Trumbull Co, SWW #22, P#
 AUMS-2,
 Knop - Mt. Summit

TO: Stephen Ochs, Mineral Resources Inspector
FROM: Glenda M. Besana-Ostman, Geologist *gmb*
SUBJECT: Application and Site Evaluation for a SWIW permit
DATE: July 25, 2012

OPERATOR: AMERICAN WATER MANAGEMENT SERVICES, LLC
WELL NAME & NUMBER: AWMS # 2 - Niles Injection Site
PERMIT NUMBER: NEW WELL, SWIW # 22
LOCATION:
AWMS # 2: 674' SL & 2153' WL of SEC 9, Weathersfield Twp., Trumbull County
PROPOSED INJECTION ZONE: NEWBURG ZONE/LOCKPORT FORMATION
DATE RECEIVED: DECEMBER 27, 2011

Attachment A: ODNR Permit Review Summary

AMERICAN WATER MANAGEMENT SERVICES, LLC		
INJECTION WELL NO. AWMS-2 DETAIL PROPOSED NILES INJECTION SITE		
SCALE: NOT TO SCALE	DATE: 12-21-11	DWG: KUR003-FIG 2

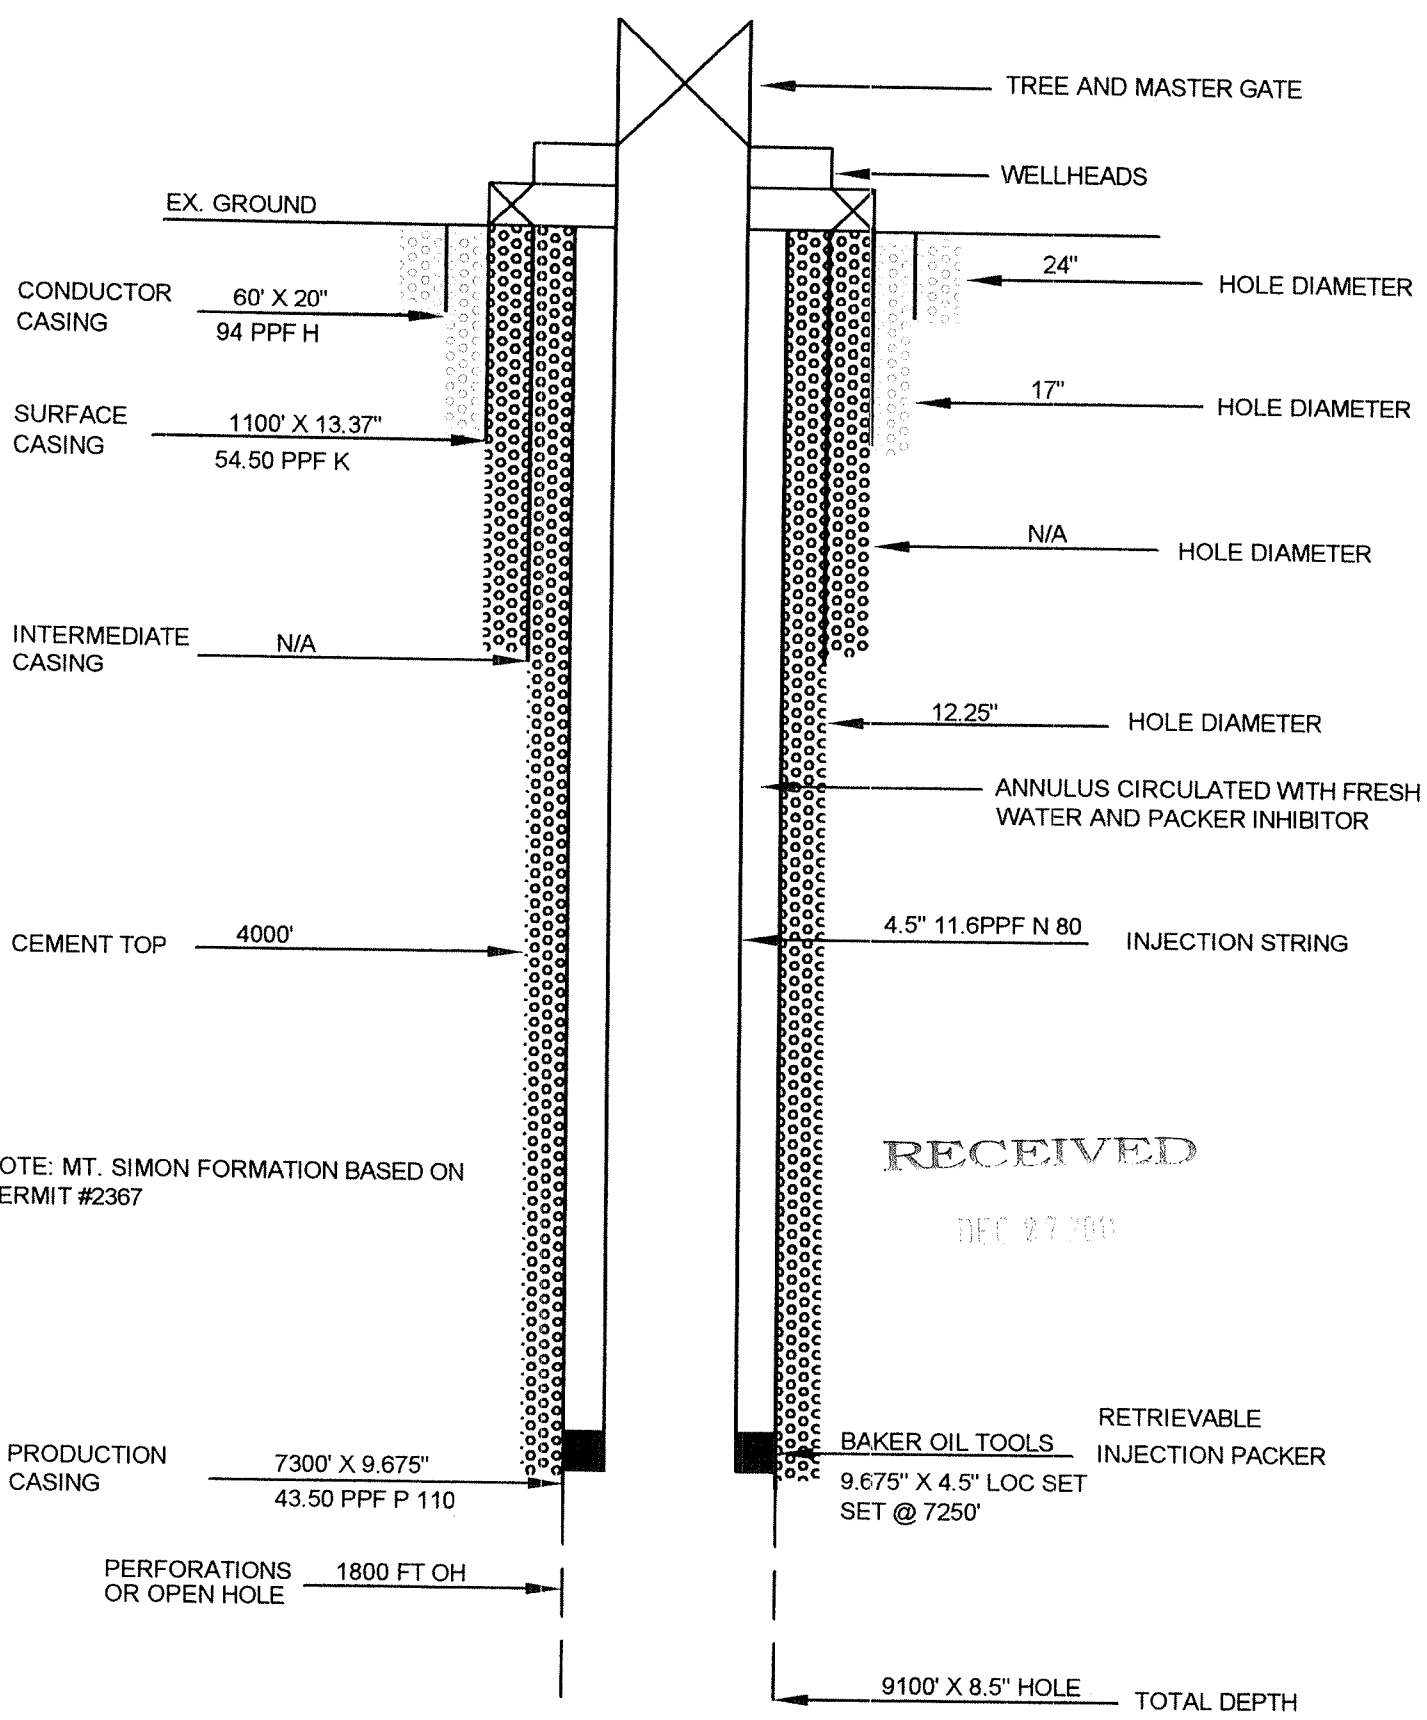
6. Trumbull Co., Weathersfield Twp. American Water Mgt. #2 AWM
 - Surface casing depth appears adequate and cemented to surface. The type of cement, and number and location of centralizers used on the surface casing should to be specified. Lack of this information limits our review.
 - The injection casing cement top is shown to surface on the diagram, but states the cement top is at 4000 feet. This should be clarified because the plat map show 112 feet between the two disposal wells (same concerns as outlined in #5).
